DEPARTMENT OF TRANSPORTATION

Quality Assurance and Source Inspection

Contract #: 04-0120F4Cty: SF/ALA Rte: 80 PM: 13.2/13.9File #: 69.28**WELDING INSPECTION REPORT****Resident Engineer:** Pursell, Gary**Address:** 333 Burma Road**City:** Oakland, CA 94607**Report No:** WIR-012185**Date Inspected:** 18-Feb-2010**Project Name:** SAS Superstructure**OSM Arrival Time:** 700**Prime Contractor:** American Bridge/Fluor Enterprises, a JV**OSM Departure Time:** 1900**Contractor:** Zhenhua Port Machinery Company, Ltd (ZPMC), Changxing Island **Location:** Shanghai, China**CWI Name:** Chen Xi.**CWI Present:** Yes No**Inspected CWI report:** Yes No N/A**Rod Oven in Use:** Yes No N/A**Electrode to specification:** Yes No N/A**Weld Procedures Followed:** Yes No N/A**Qualified Welders:** Yes No N/A**Verified Joint Fit-up:** Yes No N/A**Approved Drawings:** Yes No N/A**Approved WPS:** Yes No N/A**Delayed / Cancelled:** Yes No N/A**Bridge No:** 34-0006**Component:** OBG**Summary of Items Observed:**

CB15:

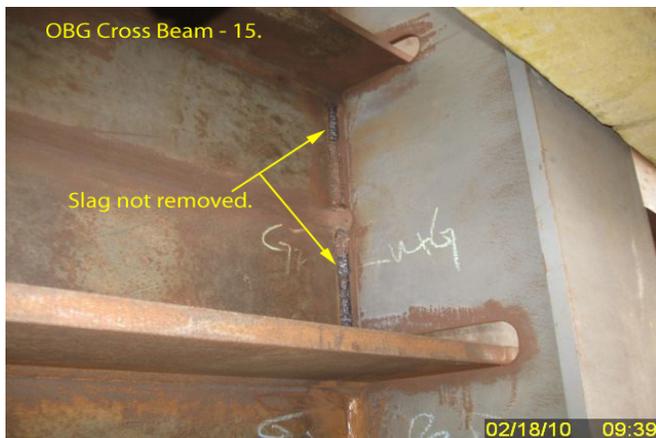
- Some of the welds having poor weld profile and slag not removed.
- Some of the cope holes do not appear to comply with the contract documents.

This QA Inspector has marked above mentioned such locations in question for the Contractors QC to inspect and evaluate. Fabrication of this CB is in progress and is not yet released for Caltrans inspection.
